# DEVELOPMENT MANAGEMENT AGENDA

# Agenda Item 5f

### ADDENDUM SHEET

Land at Grange Farm, Green Lane, Bovingdon Dacorum Planning Ref. 23/02034/MFA

**Figure 1 Annotated Extract of Map 26**

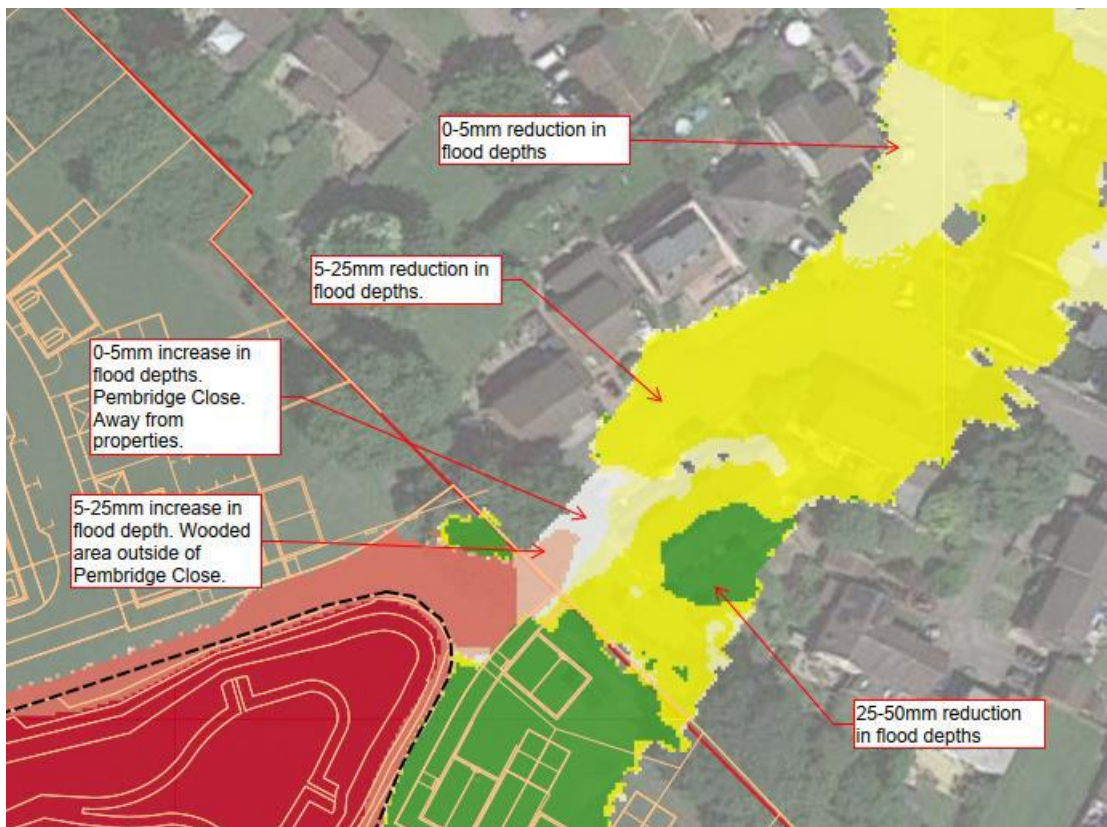
From a review of the Flood Risk Modelling report Nov 2023 by JNP, Map 26 clearly indicates an increase in predicted flood depth (of up to 25mm) across off-site areas downgradient of the site (including Pembridge Close) for the 1% AEP + 40% climate change event.

It appears that JNP, the developer's flood risk advisor, concur with my professional opinion that the proposed flood risk and drainage strategy unduly increases the risk of flooding to Pembridge Close and areas downgradient of the site.

***JNP Response:** This is incorrect, no part of Pembridge Close is shown to have an increased depth of up to 25mm. There is a very small area of woodland at the site boundary which shows an up to 25mm increase in flood depth, and an equally small area of Pembridge Close showing a 0-5mm increase in flood depth. No mention is made by DJA in the above that the vast majority of areas downstream show a reduction in flood depths including the areas closest to existing properties. See marked-up extract of Map 26 below.*

*This is not the conclusion made within the JNP Flood Risk Modelling report. Paragraph 5.1.8 "Modelling shows that the development and its water management infrastructure will reduce the amount of flood runoff leaving the site at its eastern boundary compared to existing conditions during a design storm event (1% AEP with 40% climate change adjustment) by a small amount. Flood outflow will be significantly reduced by the developed site during more frequent less severe events."*

The very minor increases in flood depth, outlined in the figure above, are a result of the redirection of flows away from existing properties, this is a clear betterment of the existing situation.
